proposed completion or recompletion. REVISED: Hilcorp Energy Company requests permission to revise the previously submitted recomplete procedure to include plugging back the Dakota formation and additional cement work. Please see the attached revised procedure. Spud Date: Rig Release Date:						
REVISED: Hilcorp Energy Company requests permission to revise the previously submitted recomplete procedure to include plugging back the Dakota formation and additional cement work. Please see the attached revised procedure. Spud Date: Rig Release Date:						
back the Dakota formation and additional cement work. Please see the attached revised procedure. Spud Date: Rig Release Date:	proposed completion or rec	completion.				
back the Dakota formation and additional cement work. Please see the attached revised procedure. Spud Date: Rig Release Date:	REVISED: Hilcorp Energy Compar	av requests permission to revise the r	previously submitte	d recomplete pro	ocedure to include plugging

State Com A2

Mesa Verde Recompletion Procedure

Operator:	OGRID:
HILCORP ENERGY COMPANY	372171
1111 Travis Street	Action Number:
Houston, TX 77002	109981
	Action Type:
	[C-103] NOI Recompletion (C-103E)

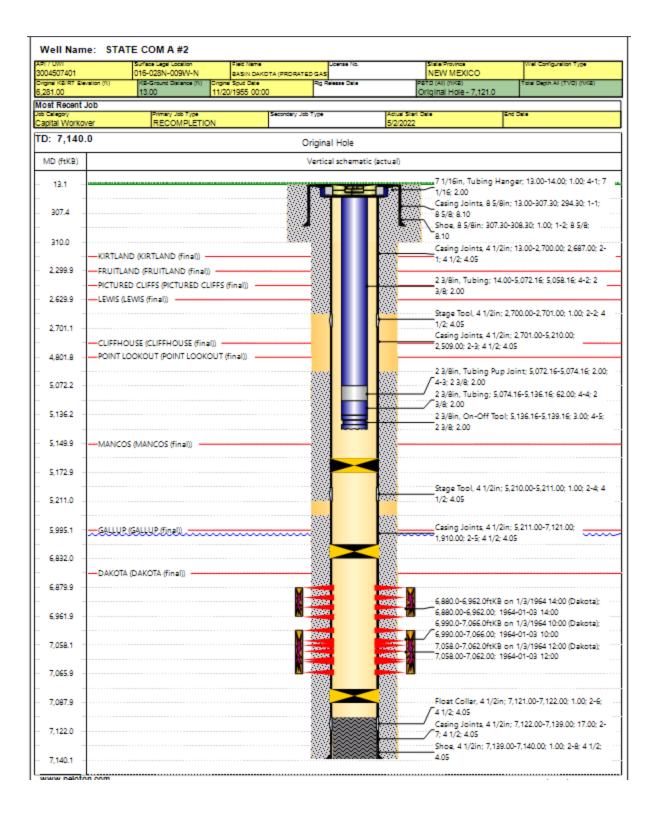
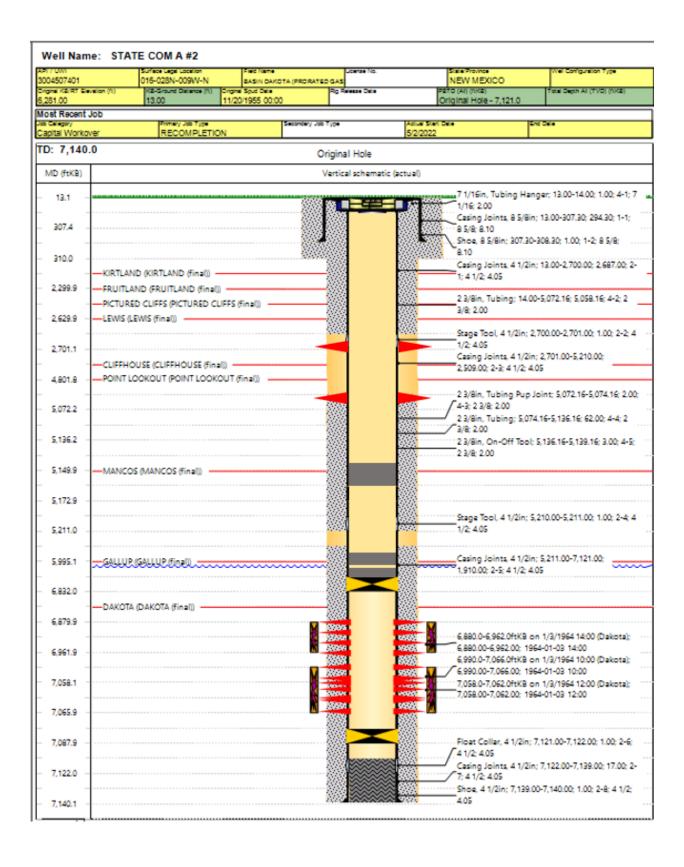
- 1. Pulled tubing and set CIBP at 7,086'
- 2. Set CIBP below Mesaverde at 6,830' and pressure tested wellbore to frac pressure (no good)
- 3. Isolate two leaking intervals from 5,223'-5,285' (inside Mancos interval we intend to abandon) and from 2,713'-2,744'
- 4. Set RBP at 5173', landed tubing at 5136'

- 1. MIRU Workover rig. ND wellhead, NU BOP.
- 2. RIH and latch RBP, POOH with RBP standing back 2-3/8' tubing
- 3. RIH to CIBP with 2-3/8"
- 4. Spot 50' (TOC at 6,780') of Type III cement to permanently abandon the Dakota perfs.

- 5. Circulate plug fluid to 6045'
- 6. Spot 150' of cement from 6045' to 5895' to cover Gallup top
- 7. Circulate plug fluid to 5200'
- 8. Spot 150' of cement from 5200' to 5050' to cover Mancos top. WOC and tag cement plug to verify top. (HIC isolated 5223-5285'). DV tool at 5210' provides outside cement coverage per CBL ran 05/06/2022 by Basin Well Logging.

- 9. Circulate fluid if needed to fill wellbore for perforating.
- 10. RU E-line and MU DP charges. RIH and perf at ±4,800' and ± 2,730'. RDMO E-Line.
- 11. PU test packer and RIH to ±4,700'. Attempt to establish injection into perforation at 4800' with water. Increase pressure in 500 PSI increments if perforations will not take fluid, do not exceed 2000 PSI.

Created By	Condition	Condition Date
mkuehling	With holes above you a casing test will not be achieved - WOC on all plugs -the Dakota plug needs to be ran from top of CIBP at 6830 to 6680 reversing out at 6045 WOC - approved - Gallup balanced plug from 6045 to 5895 reversing out at 5200 WOC - approved - With holes below Mancos top - cement retainer is advised- plug 5200 to 5050 WOC - approved - perforating +/-4700 and +/-2730 approved Contact this office with any problems that may arise - monitor bradenhead pressure - Pressure test required with witness from this office from top of Mancos plug to surface when drilled out.	5/24/2022
